STAFF RECOMMENDATION

1511 Dallas Avenue

March 18, 2015

Application: New construction - addition

ROOF PLAN
SCALE: 1/8" = 1'

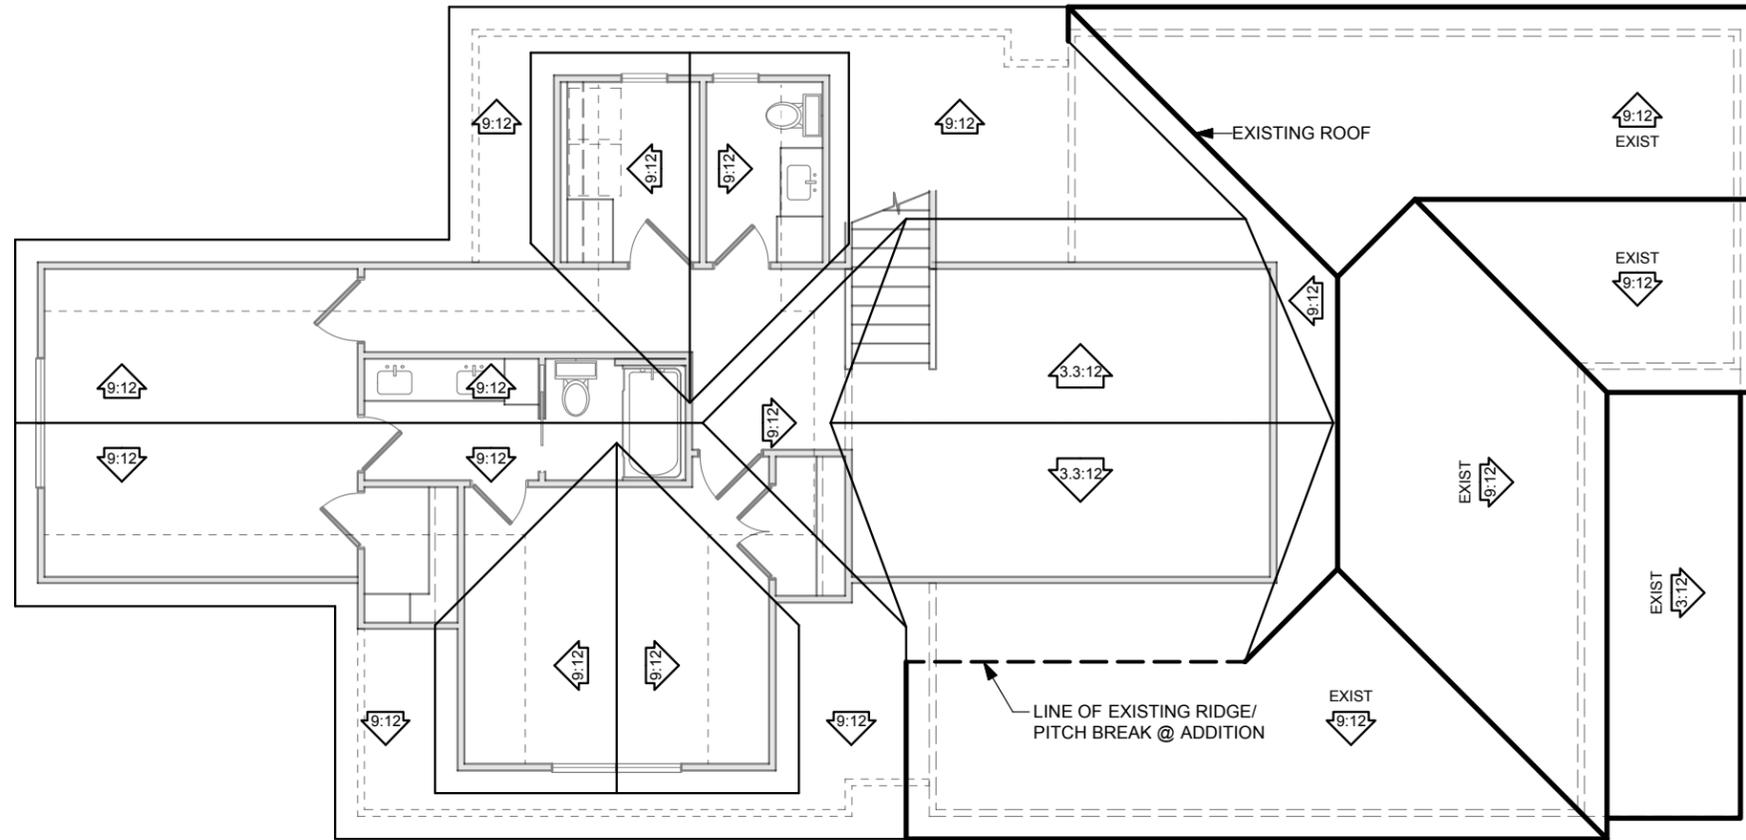
Roof form: The roof of the addition will be hipped with a 9:12 pitch matching that of the existing roof tying into the rear slope of the existing roof with a low-pitched saddle or cricket. Both sides of the primary roof of the addition will have a side-facing gabled-dormer. The dormers will sit below the roof peak and be stepped from the walls below, as is typical of historic dormers. Staff finds that the roofs of the proposed addition are compatible with the historic house and meet section II.B.1.e of the design guidelines.

LEFT SIDE ELEVATION

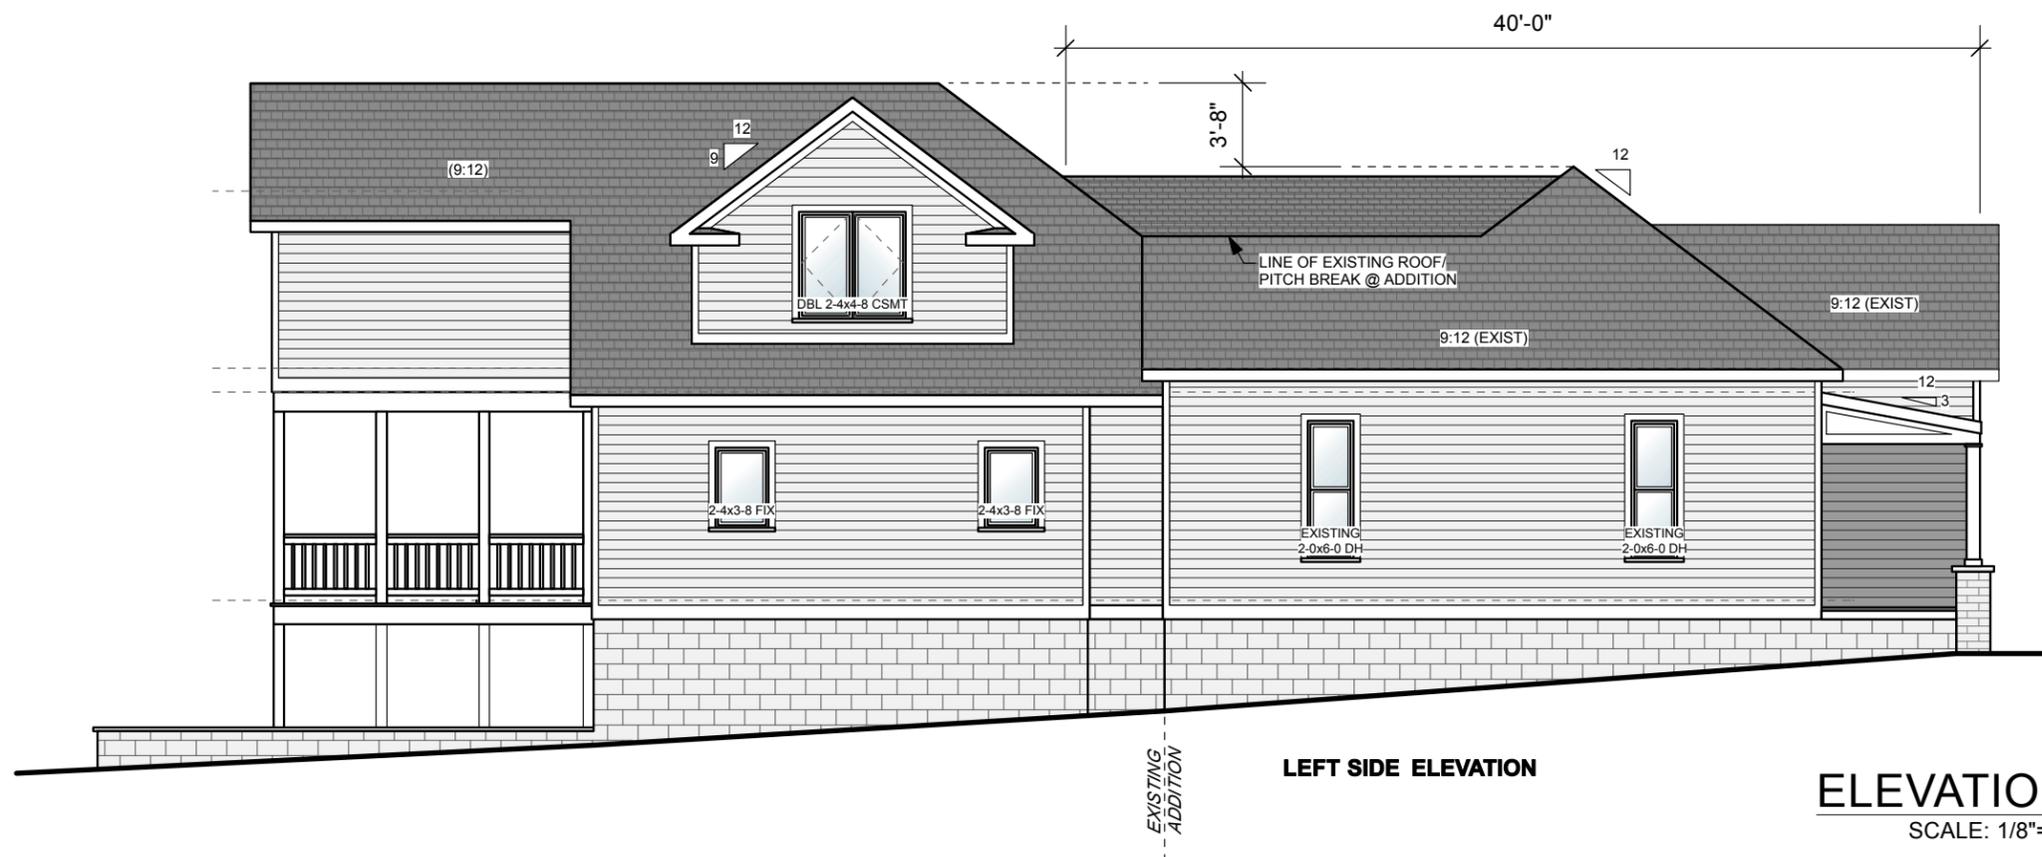
Partial Demolition: The plans indicate that an existing window on the right side will be shifted four feet (4') toward the front and a new window will be installed behind it. Staff finds the alteration of the original window pattern to be inappropriate and does not recommend approval to alter them, as the alteration does not meet section III.B.1.a for demolition. No other changes to the window and door openings on the existing house were indicated on the plans.

Recommendation: Staff recommends approval of the proposed addition with the conditions that the existing window pattern be retained, and that staff approves the roof color and the window and door selections prior to purchase and installation. Meeting those conditions, Staff finds that the project will meet the applicable design guidelines for the Belmont-Hillsboro Neighborhood Conservation Zoning Overlay.
